TEXAS COMMISSION ON ENVIRONMENTAL QUALITY

Re: Edwards Aquifer, Comal County
NAME OF PROJECT: Eden Home Expansion; Located at 631 Lakeview Boulevard; New Braunfels, Texas
TYPE OF PLAN: Request for Modification of a Water Pollution Abatement Plan (WPAP); 30 Texas Administrative Code (TAC) Chapter 213 Edwards Aquifer
Edwards Aquifer Protection Program File No. 1282.01
Regulated Entity ID: RN101762425
Investigation Number: 512694

The Texas Commission on Environmental Quality (TCEQ) has completed its review of the request for modification of the approved WPAP for the referenced project submitted to the San Antonio Regional Office by The Schultz Group, Inc. on behalf of Eden Home, Inc. on September 8, 2006. As presented to the TCEQ, the Temporary and Permanent Best Management Practices (BMPs) and construction plans were prepared by a Texas Licensed Professional Engineer to be in general compliance with the requirements of 30 TAC Chapter 213. These planning materials were sealed, signed, and dated by a Texas Licensed Professional Engineer. Therefore, based on the engineer's concurrence of compliance, the planning materials for construction of the proposed project and pollution abatement

Detail Showing
Feature Sealing Solution

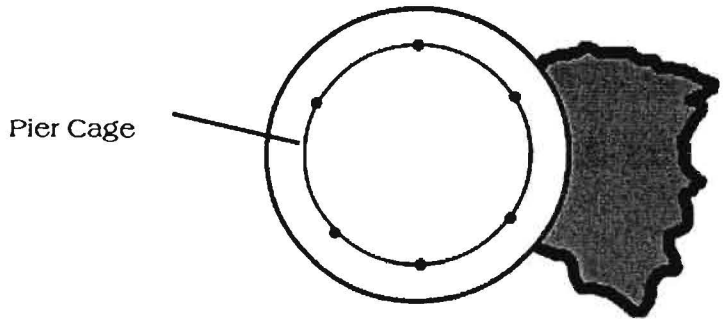
Frost GeoSciences, Inc. recommends that the solution feature be sealed with a shallow plug (2 to 3 feet tall) of low slump (2 to 3 inch Max) concrete (4000 psi). The plug should be set from the existing concrete level to 1 foot above the cavity. Once this sets, the remainder of the pier can be poured to the top with concrete meeting the original plans and specifications. A detailed drawing of the proposed solution is included on Figure 1.

1. The location of the solution cavity shall be shown on the "as-built" plans.
2. In accordance with TAC § 213.5(f)(2), immediately notify the TCEQ if a new feature is discovered with continuation of construction activities.
3. The treatment method is designed to address environmental concerns related to surface water infiltration and is not intended to address structural integrity issues.
